JOINT REGIONAL PLANNING PANEL REPORT

Application No.	D/2014/713
Address	22 George Street, LEICHHARDT NSW 2040
Proposal	Site preparation works including remediation and construction of five residential flat buildings, incorporating 287 apartments and 5 commercial tenancies and associated landscaping and basement parking.
Date of Receipt	23 December 2014
Applicant	Greenland (Sydney) George Street Development Pty Ltd
Owner	Greenland Sydney George Street Development Pty Ltd
Number of Submissions	105
Building Classification	2, 6 and 7a
Integrated Development	Yes
Main Issues	Contamination, SEPP 65 non-compliance
Recommendation	Refusal

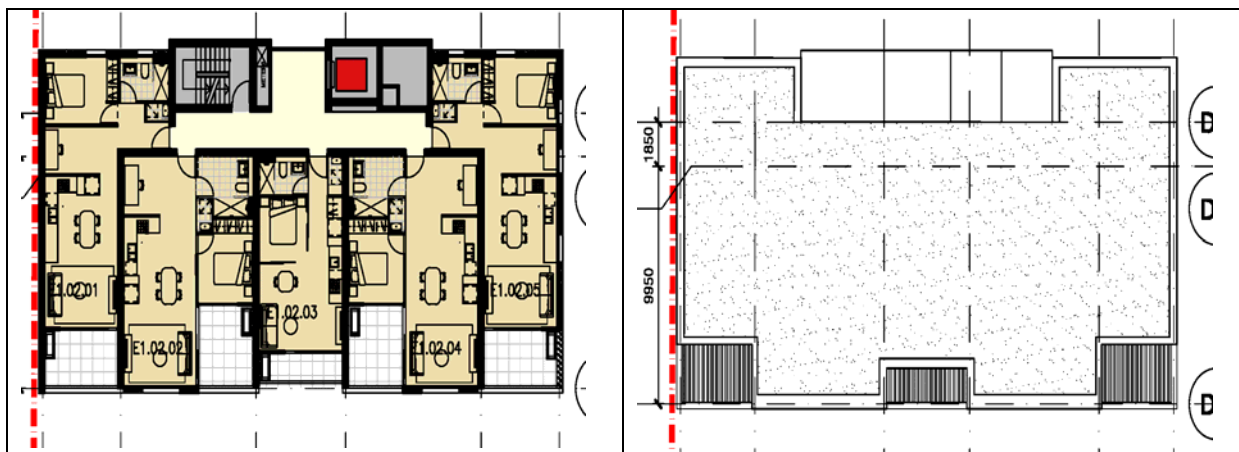
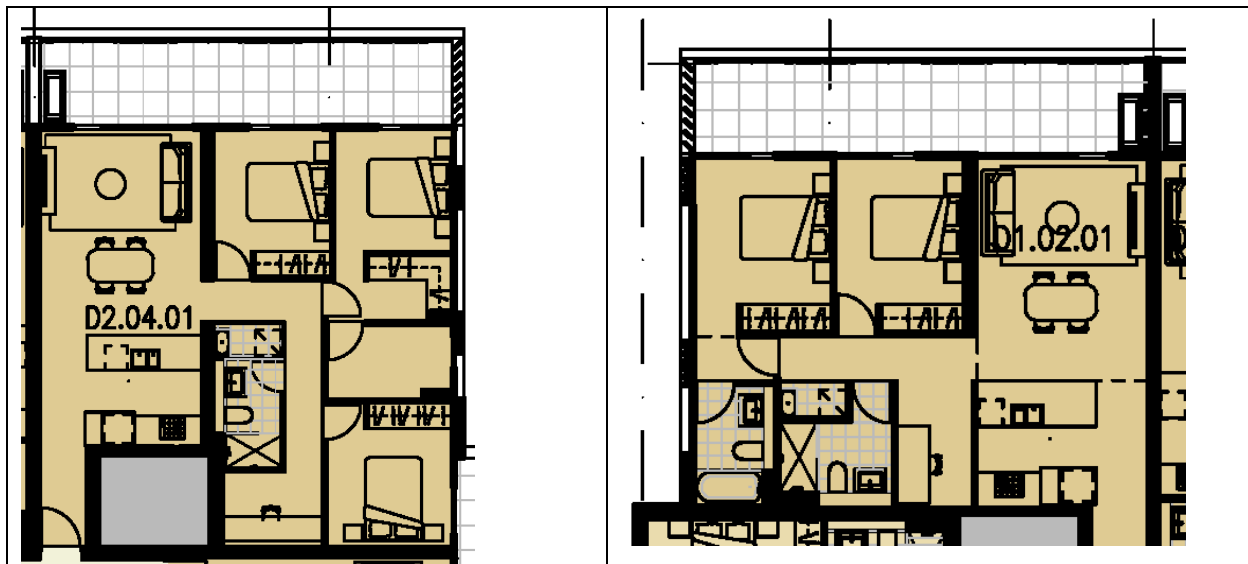
The extract above purports to demonstrate solar access at 9.00am to the northern most unit of the ground level of Building E, however as is clear from the floor plans this unit has a blank northern wall hard on the boundary with the Labelcraft site, with no windows, and cannot therefore obtain the sunshine indicated in the second column above. This is repeated for all units at this location.

Council has identified approximately ten units across the development which appear to have similar discrepancies.

One solution identified by staff would be to insert solar scoops/skylights to the top five units of Building E. The diagram below has been included to demonstrate this possibility.

The extracts above demonstrate five dwellings with living rooms which would benefit from skylights or similar in terms of additional solar access.

A condition of consent is therefore proposed in order to bring this into effect. This would have the effect of improving solar access under to SEPP to approximately 64%.

Diagram: Amended entry layout to basement car park – pedestrian access separated - building footprint east-west reduced and communal space opened up

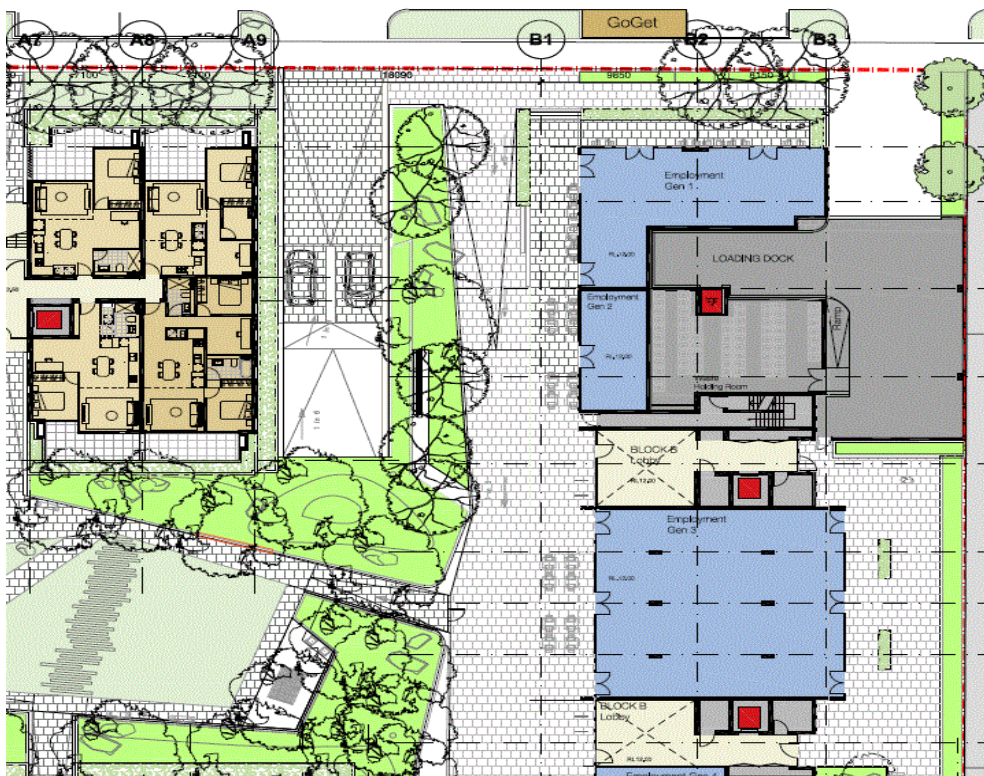
Council accepts that the applicant's preferred design results in better amenity outcomes for users of the plaza, through-link and retail/café tenancy, as this area would be less visually overwhelmed and much less overshadowed. The modification also allows the north facing units of Building B to have largely unfettered solar access.

Diagram: Floor plan of top level (9th storey) units facing George St.

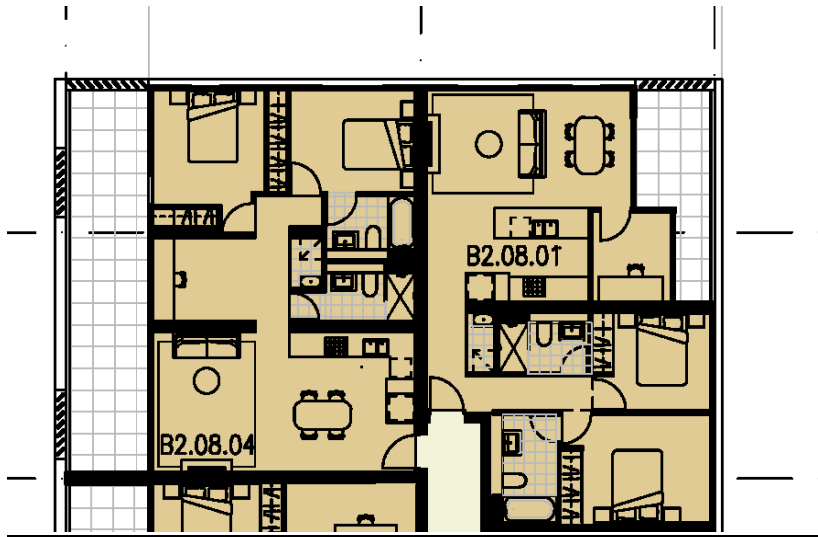
The addition of a ninth storey to Building B is compatible with the over-riding height limit in the Leichhardt Local Environmental Plan 2013. More importantly, it is achieved in a location which creates no further overshadowing to any nearby residential dwelling or property than that already allowed for under the DCP 2014. In terms of overlooking, the development of an additional storey results in two additional units having potential view-lines to the backs of Flood Street properties.

DCP setback recommendations Applicant's alternative with greater setbacks

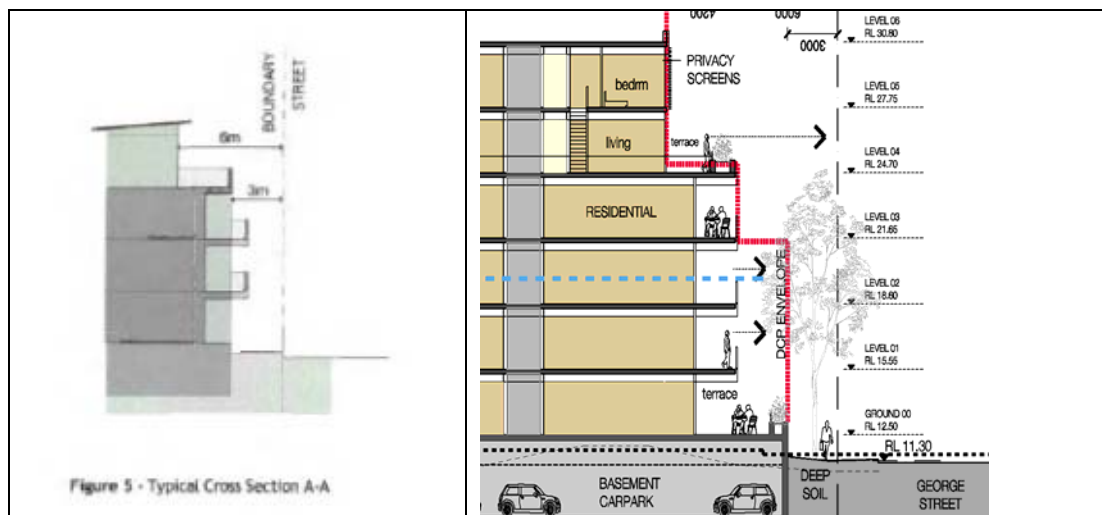
The modification of Building A from 3 and 4 storeys to 4 and 6 storeys has also been examined with regard to justification for this redistribution. The two additional storeys would result in some additional overshadowing to the central communal space during the morning at different times of the year, but the orientation to true north means that this internal impact is very limited, and other changes to building footprint have resulted in better solar outcomes for the communal space overall.

The addition of these two extra storeys does not result in additional overshadowing to the rear of the Flood St neighbours, partly because the design has incorporated greater setbacks from the George Street boundary than the DCP suggests.

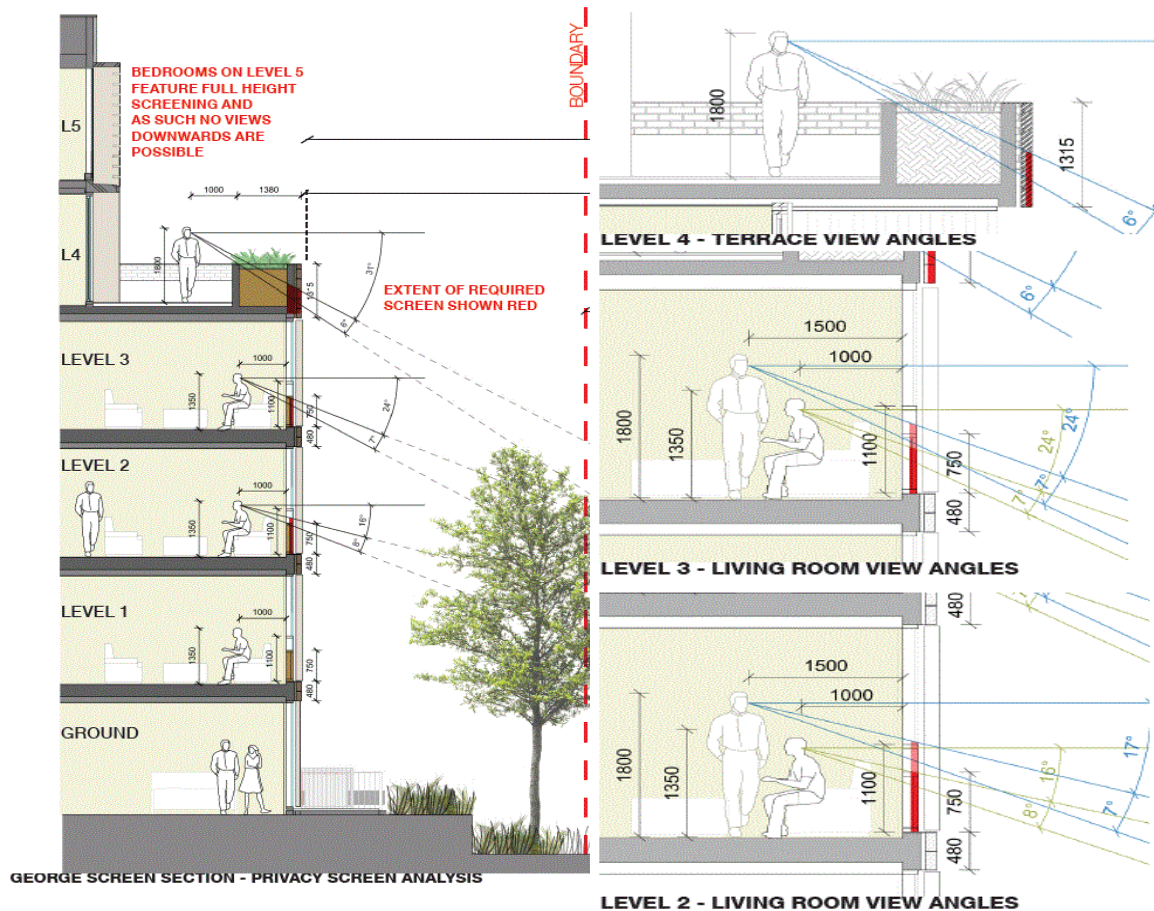
With regard to overlooking, the design has proposed two-level dwellings utilising the top two floors, with living rooms/balconies on the lower levels, and bedrooms above. The bedroom windows are proposed to be fully screened. The balconies at the lower levels will be screened by a solid spandrel to a height of 750mm, combined with a 350mm high translucent glass spandrel. In relation to level 4 terraces, the proposed

planter boxes have been raised to 1380mm high to eliminate downward looking, as demonstrated in the below graphics.

This approach is supported by Council and will appropriately mitigate overlooking to the surrounding residential properties.
